Re: Responses to Recommendations in Final Coal Combustion Waste Impoundment
Round 7 - Dam Assessment Report for Riverside Generating Station

Riverside Generating Station Recommendations

Re: Interim Report - Results of Global Stability Analyses Revisions
South Ash Containment Pond Embankments
Riverside Generating Station
Bettendorf, Iowa
Terracon Project No. 07105081/02105081G

Re: Geotechnical Report Addendum No. 2
Revised Global Stability Analyses
South Ash Containment Pond Embankments
Riverside Generating Station
Bettendorf, Iowa
Terracon Project No. 07105081/02105081G

Bedding material on improved slope
Direction Looking: South

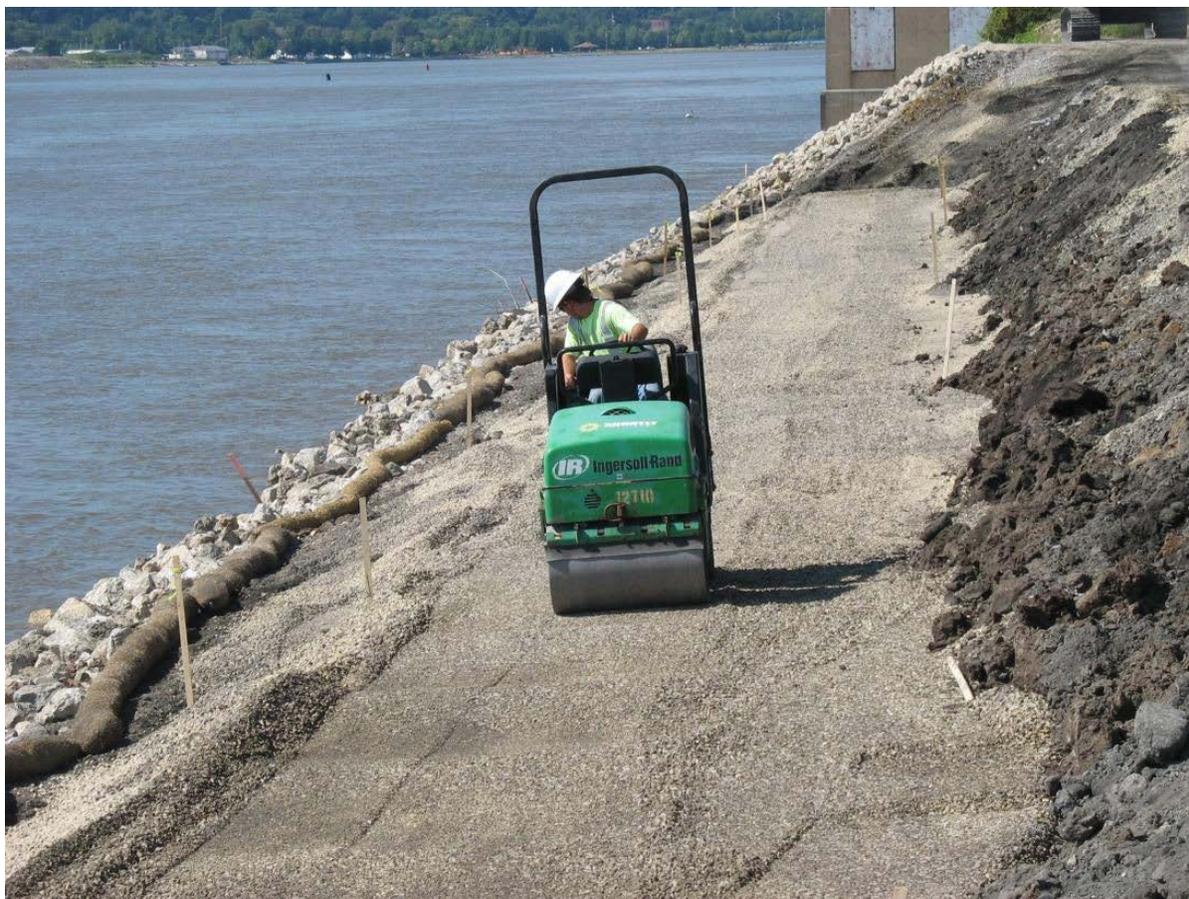
EPA Comment: Corrective measures should be implemented to improve the stability of the South Ash Pond in order to meet required safety standards for dams. MEC is aware of the deficiency and is preparing and intends to implement plans to address this concern. USEPA has requested that MEC document their plans for the improvement.

EPA Comment: The South Ash Pond needs immediate remedial action to improve the factors of safety against slope instability.

MEC Response: A project was initiated June 17, 2011, to improve the slope stability factor of the South Ash Pond such that it meets or exceeds the required factor of safety of 1.5. MidAmerican Energy Company (“MidAmerican”) retained a qualified contractor to install dewatering wells and inclinometers, excavate the existing rip rap armor components, excavate the existing levee embankment material down to an elevation of 564 Mean Sea Level, and replace the embankment in compacted layers utilizing suitable materials and geogrid reinforcement. The majority of the project has already been completed and it is on schedule for final completion in September 2011.

The following photographs provide visual documentation of the status of the South Ash Pond levee improvement project.
